**CITY OF TEMPE
DEVELOPMENT REVIEW COMMISSION**

Meeting Date: 09/26/2017
Agenda Item: 3

ACTION: Request for Development Plan Review consisting of a new office building for Lot 4 BTS, located at 2106 E Rio Salado. The applicant is Butler Design Group.

LOT 4 BTS

SITE PLAN
09-12-17
15096.004-ST29

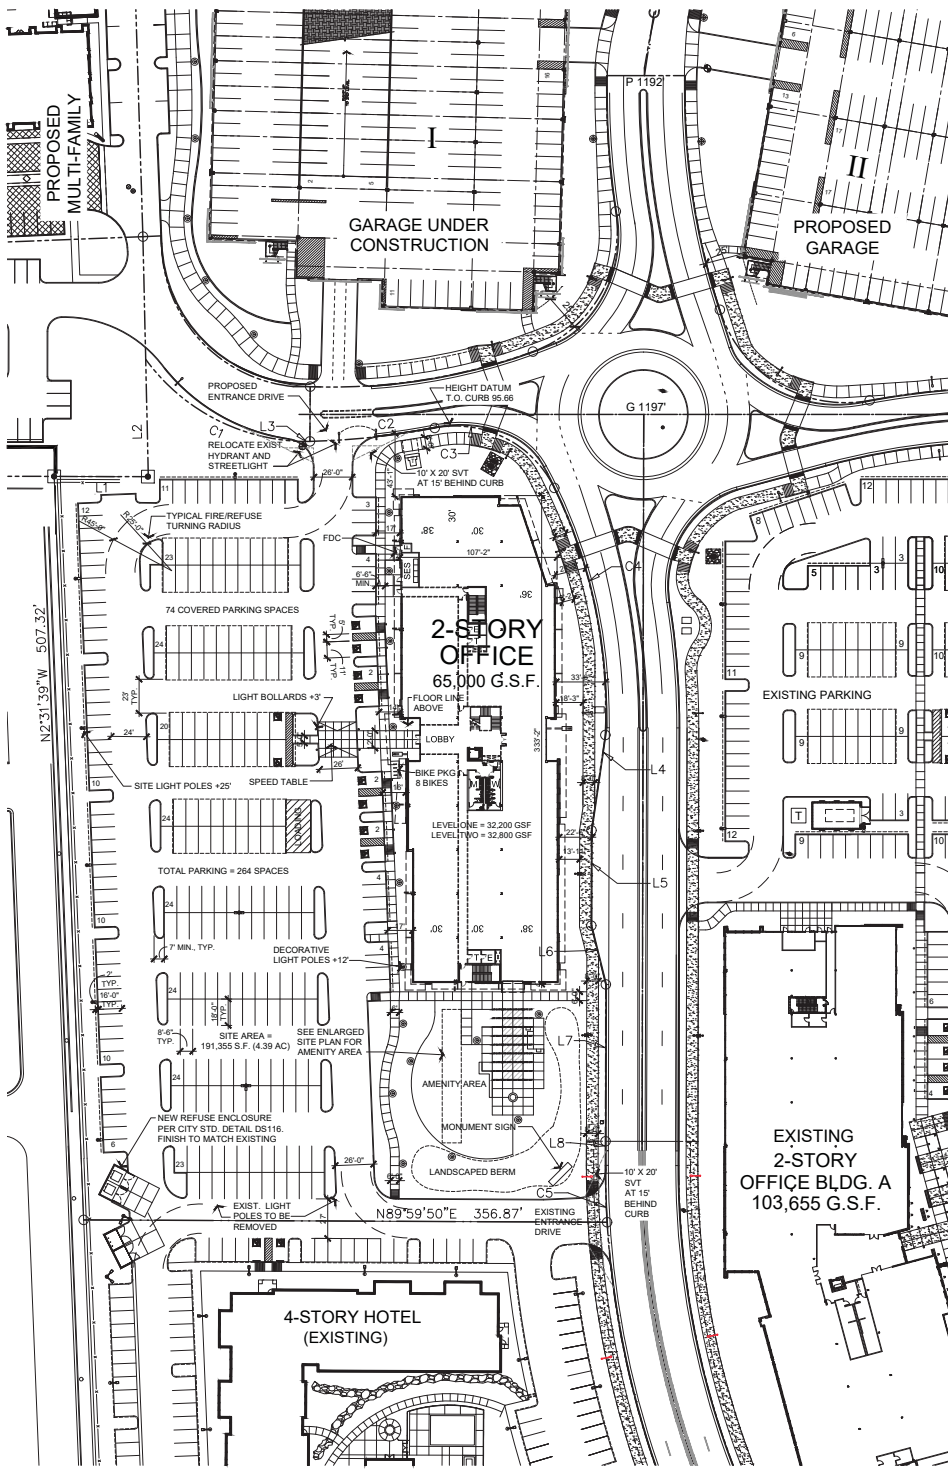
July 12, 2017 First Preliminary Site Plan Review for Lot 4 BTS was a site plan, no landscape plan or elevations. This site had been previously reviewed and the building footprint was substantially the same as the approved Planned Area Development. Comments were primarily formatting or questions for clarification including what was proposed for the amenity area south of the building. Staff requested that bike racks be moved north, closer to the entry door. Staff requested that the entry sidewalk along the west side of the building be moved to accommodate shade trees on the west side, or a shade trellis for pedestrian comfort.

August 7, 2017 Formal Submittal was made including all required plans. The canopy over the entry extends from the second floor, and does not provide shade to the pedestrian level; staff requested that more shade/shelter be provided at the pedestrian level. Artificial turf was proposed for the amenity area on the south side; although this may work for the bocce court, it may be excessively hot surrounding the area due to the heat absorption impacts of artificial turf. Staff recommended real turf. Staff recommended more mounding and spreading plants on the landscape berm on the south east side of the site, for greater coverage of the gravel area. Staff asked for a material legend for all materials and more notes regarding details of the elevation design such as window and canopy depth dimensions, reveals, grout patterns, etc.

September 8, 2017, a resubmittal was made that moved bike parking closer to the front doors, and made technical content changes as requested. The canopy on the west side was not modified, but the applicant explained that the first floor is recessed under the second floor, providing shelter, and the design of the landscape area provides additional shade to the west entryway. The artificial turf is a function of the existing underground condition of this lot, and all the properties within this development, that requires minimizing water percolation into the compacted landfill substrate. This area is shaded by trees and screened by berms of mounding plants around the employee amenity area.

The office building is oriented with the 330' long building faces to the west (entrance from parking) and east, and narrower 100' sides to the north and south (access to the amenity area). The site has covered parking for 74 of the 264 spaces and shade trees shading approximately 61 additional spaces, shading about half of the parking. The south side is heavily landscaped around the amenity area, which includes a bocce court and shade canopy with bbq grills and outdoor seating. The site is being designed for a specific tenant with unique design considerations for the employees. The sidewalk from the private drive on the east side wraps around the building, providing pedestrian access on all sides of the building, with entrances on the west and south sides.

3. Provide service yard and mechanical (cooling tower/generator) yard walls that are at least 8'-0" tall as measured from adjacent grade and are at least the height of the equipment being enclosed, whichever is greater. Verify height of equipment and mounting base to ensure that wall height is adequate to fully screen the equipment.

4. Provide gates of steel vertical picket, steel mesh, steel panel or similar construction. Where a gate has a screen function and is completely opaque, provide vision portals for visual surveillance. Provide gates of height that match that of the adjacent enclosure walls. Review gate hardware with Building Safety and Fire staff and design gate to resolve lock and emergency ingress/egress features that may be required.

PRELIMINARY LANDSCAPE PLAN

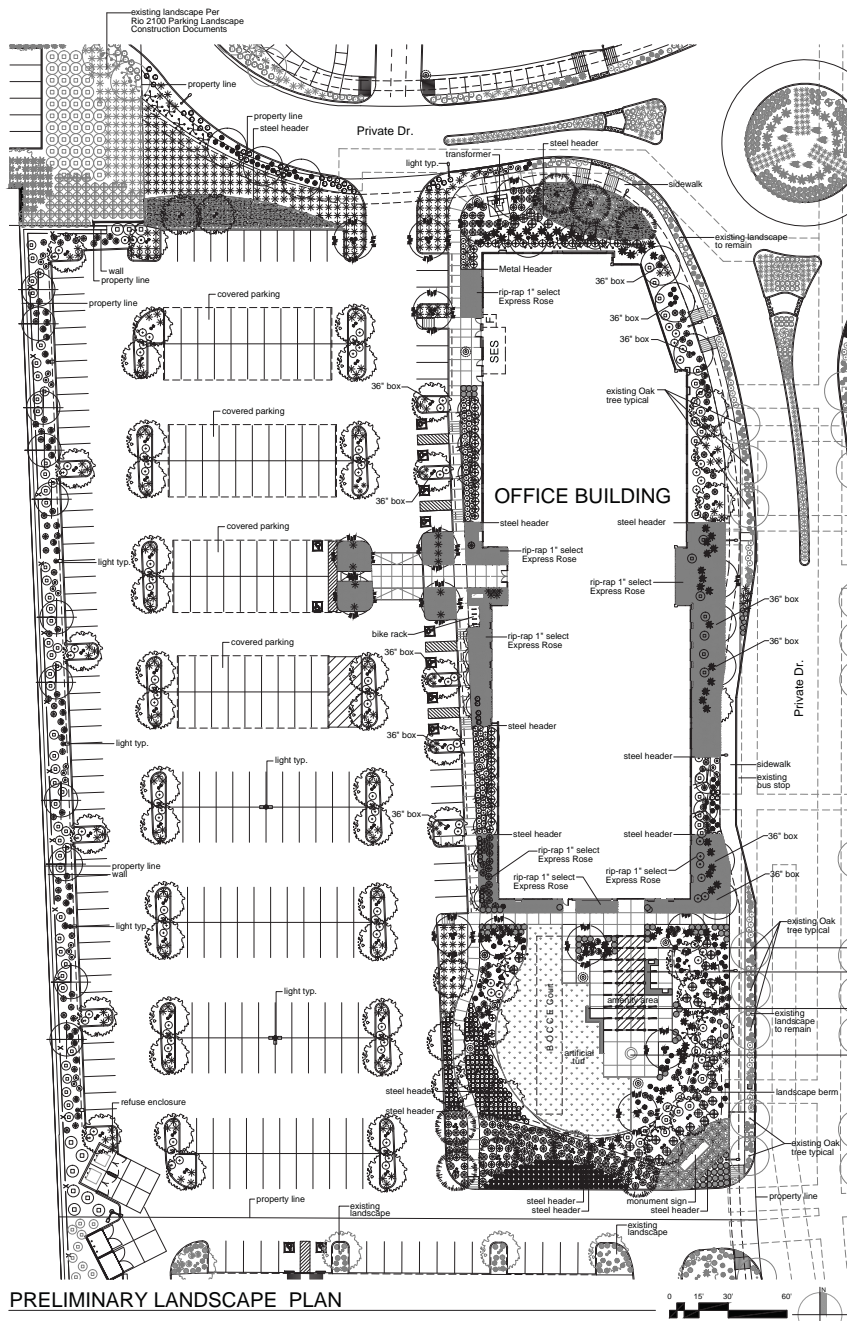
The site was deep impact compacted and capped as part of the landfill closure process. As a result, the site is limited on what types of plant materials may be used, to minimize water percolation into the lower soil levels. Low water use desert plants provide the palette for the site, with a relatively high density of tree coverage. The site provides 25% landscape coverage, 15% more than required by code. The private drive street tree was changed during permitting from Mesquite to Live Oak as the primary tree along the street front. Desert Museum Palo Verde remains the secondary tree with Mesquite and Palo Brea as tertiary tree species. Desert Museum is used predominantly in the parking lot landscape islands and red Nerium Oleander and yellow Caesalpinia Mexicana are used as accents near the building. Willow Acacia is used in the area at the far west side of the site.

15. Irrigation notes:
 - a. Provide dedicated landscape water meter.
 - b. Provide pipe distribution system of buried rigid (polyvinylchloride), not flexible (polyethylene). Use of schedule 40 PVC mainline and class 315 PVC ½" feeder line is acceptable. Class 200 PVC feeder line may be used for sizes greater than ½". Provide details of water distribution system.

16. Include requirement to de-compact soil in planting areas on site and in public right of way and remove construction debris from planting areas prior to landscape installation.

17. Top dress planting areas with a rock or decomposed granite application. Provide rock or decomposed granite of 2" uniform thickness. Provide pre-emergence weed control application and do not underlay rock or decomposed granite application with plastic.

B&W BUILDING ELEVATIONS

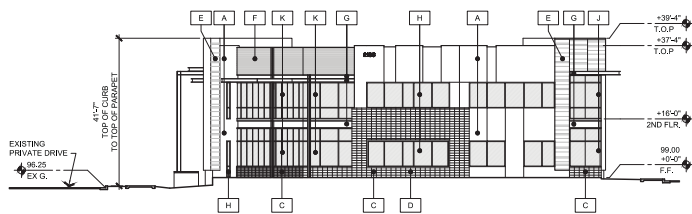
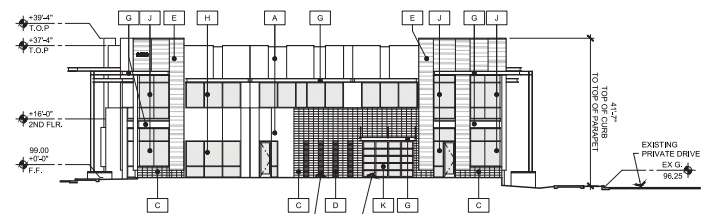
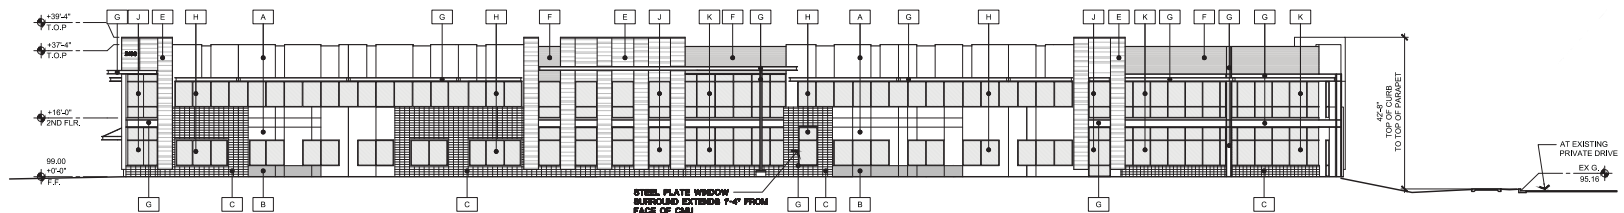
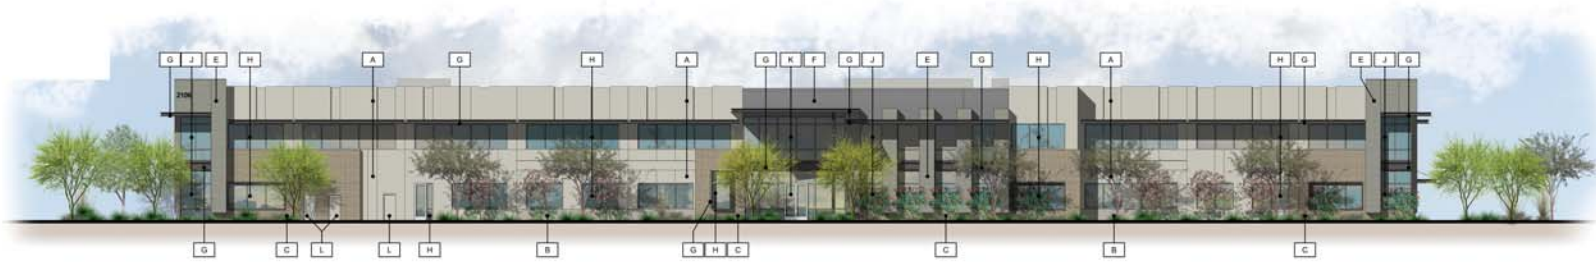
The proposed two-story building varies in height from 36-41 feet and is designed to complement the corporate office to the east in color and building massing and style. The predominant material is tilt panel concrete. The east and west sides facing the street and parking lot 330' long rhythm of office windows. Vertical building elements wrapped in metal paneling and first floor portions accented by running bond grouted integral colored ground faced masonry veneer both materials and forms break the window pattern and massing, adding visual interest in both the pedestrian level and as viewed from a distance. Steel canopies are used over entryways and as shade elements to windows. The north side has more glazing than the south elevation for better solar control. The primary color is shades of medium and light warm and cool greys. The building is a simpler structure than the lot to the east but sets itself apart from the hotel uses in terms of form, color, massing and materials.

8. The materials and colors are approved as presented:
 - Roof – Flat with parapet
 - Primary Building – Concrete tilt wall panel painted Dunn Edwards 'Muslin' DE6227 LRV 59

Secondary Building – Shiplapped metal panels 'Zinc Metallic' by Western states Metals
Tertiary Building – Concrete Masonry Units 8" x 8" x 16" integral color 'Pebble Beach' Trendstone by Superlite.
Building Accent – Concrete tilt wall panel painted Dunn Edwards 'Play on Gray' DE6228 LRV 43
Building Accent - Concrete Masonry Units 4" x 4" x 16" integral color 'Pebble Beach' Trendstone by Superlite.
Building Accent – Box Rib Metal Panels Masterline 16 Concealed fasteners 'Slate Gray' by MBCI
Windows - Anodized aluminum frame
Glazing – Viracon insulated glass (3 colors) - VE1-85 Medium Blue Gray, 1-38 Light Blue Grey and VRE1-30 Clear
Trim - Painted steel – Painted Dunn Edwards 'Jet' DE6378
Hollow Metal Doors and Frames – painted to match adjacent tilt wall
Provide primary building colors and materials with a light reflectance value of 75 percent or less. Additions or modifications may be submitted for review during building plan check process.

9. Provide secure roof access from the interior of the building. Do not expose roof access to public view.
10. Conceal roof drainage system within the interior of the building.
11. Incorporate lighting, address signs, and incidental equipment attachments (alarm klaxons, security cameras, etc.) where exposed into the design of the building elevations. Exposed conduit, piping, or related materials is not permitted.
12. Locate the electrical service entrance section (S.E.S.) inside the building or inside a secure yard that is concealed from public view.
13. Upper/lower divided glazing panels in exterior windows at grade level, where lower glass panes are part of a divided pane glass curtain-wall system, shall be permitted only if laminated glazing at these locations is provided.
